MONTGOMERY COUNTY HISTORIC PRESERVATION COMMISSION
STAFF REPORT

Address:	22 Hesketh St., Chevy Chase	Meeting Date:	2/27/2019
Resource:	Contributing Resource Chevy Chase Village Historic District	Report Date:	2/20/2019
Applicant:	Maggie & Robert Marcus	Public Notice:	2/13/2019
Review:	HAWP	Tax Credit:	N/A
Case Number:	35/13-19E	Staff:	Dan Bruechert
Proposal:	Fencing and Hardscape Alterations

Perspective of Proposed Components

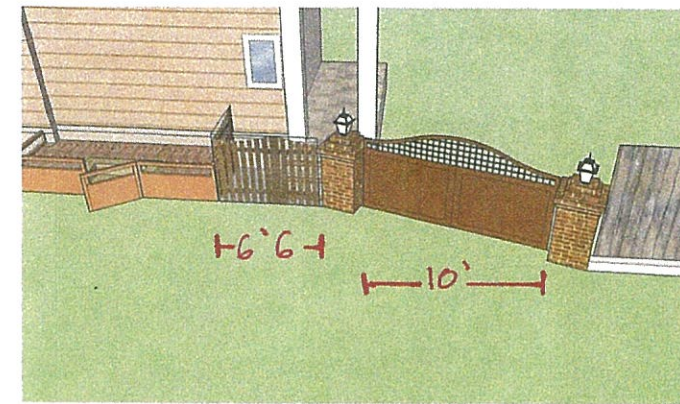
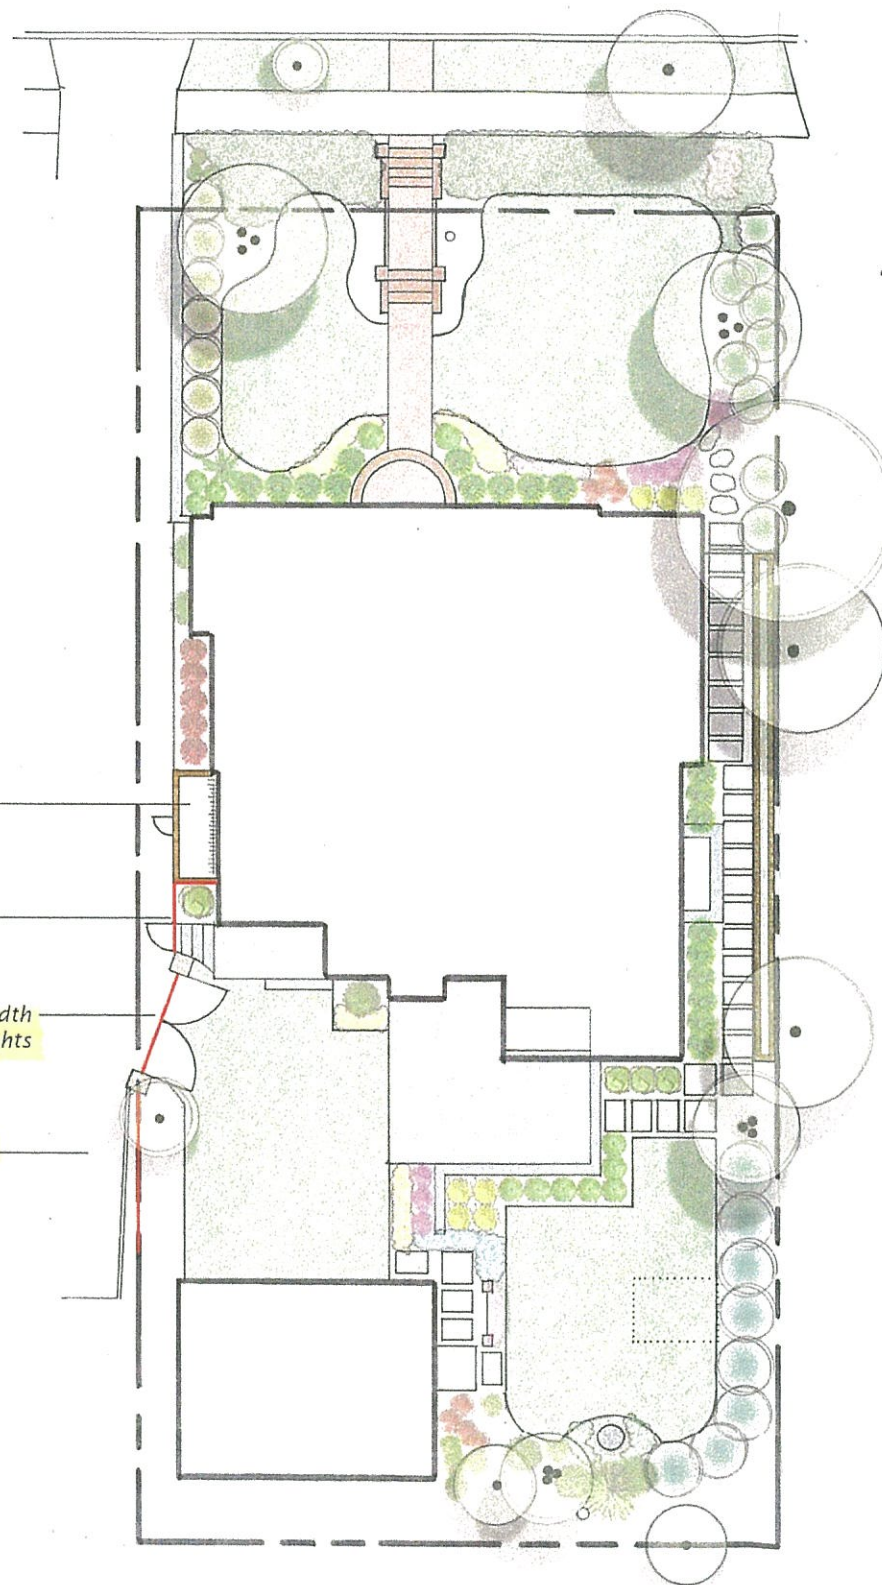
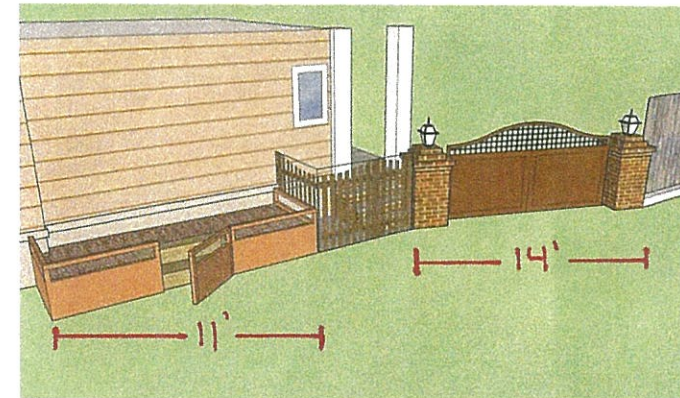
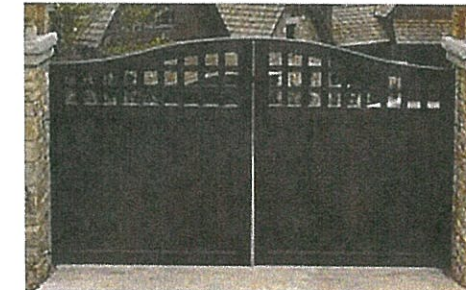
The materials proposed for these features are wood and brick. These materials are found throughout the house and grounds. The clapboard siding on the house is wood, and wood is seen as a historically appropriate fencing material. Additionally, there is extensive use of brick around the house in the front steps and retaining wall adjacent to the driveway. Staff finds the proposed wood and brick are appropriate for the house and surrounding district.

Staff further finds that the design of the three elements are appropriate with the house and will not threaten the integrity of the house. The raised bed will be low to the ground at a little more than 2' (two feet) tall and will not have a visual impact due to the lot's slope up from the street. The cedar picket fence is 4' (four feet) tall and is open enough that it provides for some transparency at the rear. The vehicular opening is generally consistent with what existed prior to the 2017/2018 rehabilitation project. Due to the shared driveway and placement of the garage, the vehicle gate needs to be installed at this oblique angle. The solid panels with lattice above will not obscure any historic resources and the decorative brick piers are consistent with the high styled Dutch Colonial Revival house.

Staff finds these elements are appropriate in design, scale, and materials and recommends approval.
